REMARKS

Serial No.: 10/063,331

For: **INTEGRATED CIRCUIT WITH CAPACITORS HAVING A FIN STRUCTURE**
(as amended herein)

REQUEST FOR APPROVAL OF DRAWING CORRECTIONS

FIG. 8

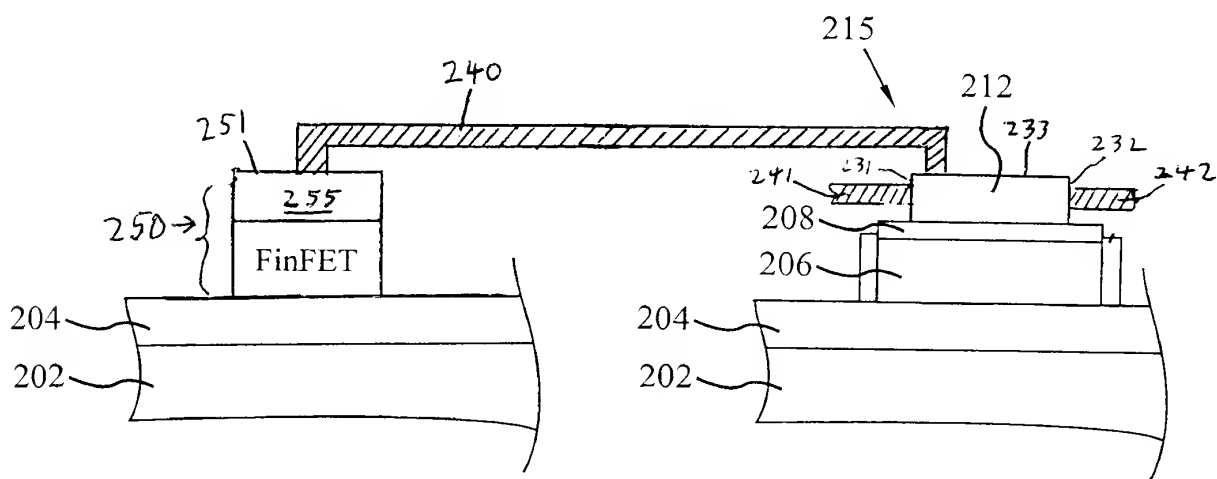
The Examiner alleged: “Claim 2, the phrase “at least one first interconnect disposed adjacent one of the top surface, the first side surface, and the second side surface of the at least one Fin structure” is not described in the specification and the figure.”

The Examiner alleged: “Claim 3, the phrase “at least one second interconnect disposed adjacent the at least one conductor structure” is not described in the specification and the figure.”

The Examiner alleged: “Claim 8, the phrase “a FinFET is disposed on the substrate, the FinFET having a gate electrode coupled to said conductor structure” is not described in the specification and the figure.”

The Examiner alleged: “Claim 10, lines 13-14, the phrase “the second conductor structure partially overlays is within a thickness of the second Fin structure” is not described in the specification and the figure.”

In response to the preceding allegations by the Examiner, Applicants have amended the drawings herein to add a new FIG. 8 which depicts the preceding subject matter alleged by the Examiner to not be depicted in the drawings. In addition, Applicants have described FIG. 8 in a new paragraph added herein by amendment. FIG. 8 and the new paragraph does not include new matter as shown in Appendix A and Appendix B.

Figure	Item/Support
FIG. 7b	FIG. 7b merely adds symbols denoting various thicknesses.
FIG. 8	The FinFET 250 as being on the buried insulator 204 and being coupled (by the interconnect 240) at its gate electrode 255 to the gate electrode 212 of the capacitor 215 is disclosed in claim 8 of the originally filed patent application. The interconnects 241 and 242 are disclosed in claims 2 and 3 of the originally filed patent application.
